TMC SPECIFICATION

NO. S 1095

TMC MODIFICATION KIT-186

FOR RFD-1A

UNIT SHOWING SIDE PANEL REMOVED AND EXTENDING OVER EDGE OF WORK BENCH TO FACILITATE MOUNTING OF NEW ASSEMBLY A-4256-2

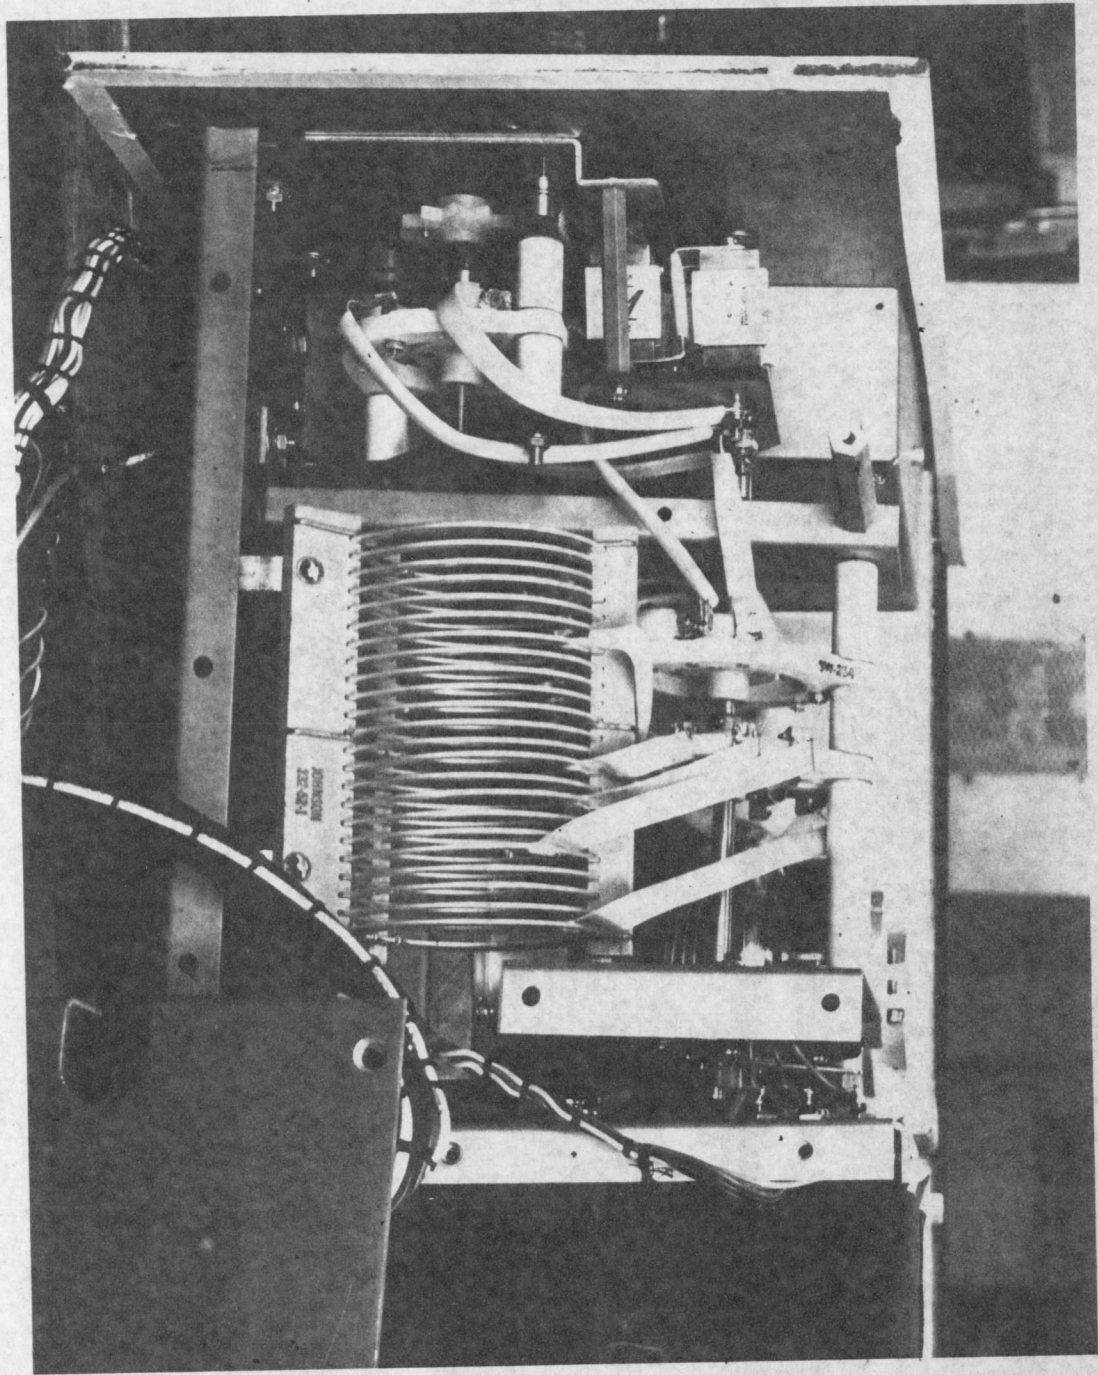
3. Drop the side panel to the side with the edge of the RFD protruding over the edge of the workbench. (SEE PHOTOGRAPH).
 4. Remove metal "Meter Cover Box", two nuts on bottom and two screws at top.

11. Place new capacitor assembly A-4256-2 over and behind S-203 with switch shaft of S-203 in slotted part of new capacitor assembly, A-4256-2.
 12. Line up mounting holes of new capacitor assembly with S-203. Replace mounting screws and tighten in place.

COMPLETED UNIT WITH ASSEMBLY A-4256 SIDE PLATE, AND METER COVER REPLACED.

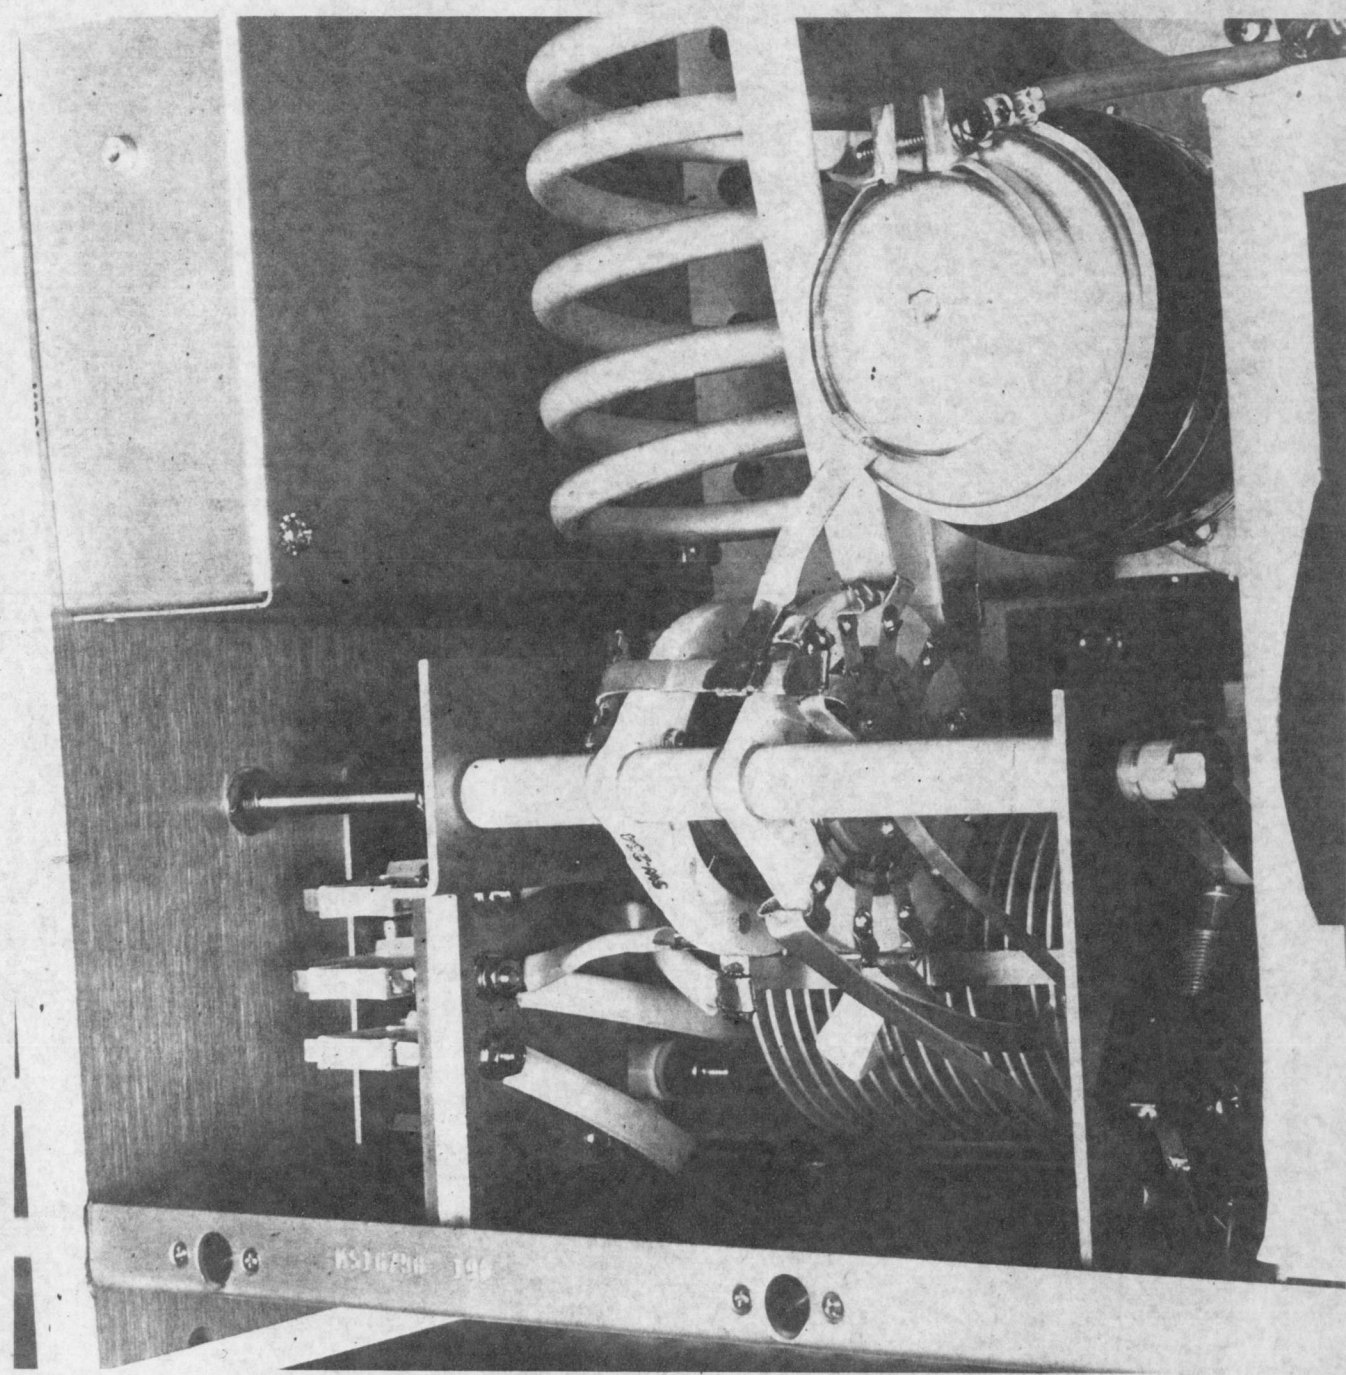
16. Solder remaining end of the short lead to the top contact of S-202 (right hand side when facing the front panel). (SEE PHOTOGRAPH PAGE 5)
17. Replace "PA BAND SWITCH" shaft and coupling.

18. Replace side plate, meter cover box, top and bottom covers.
19. Attach new nameplate to RFD-1A directly below present one. This modification changes the RFD-1A to RFD-1B.
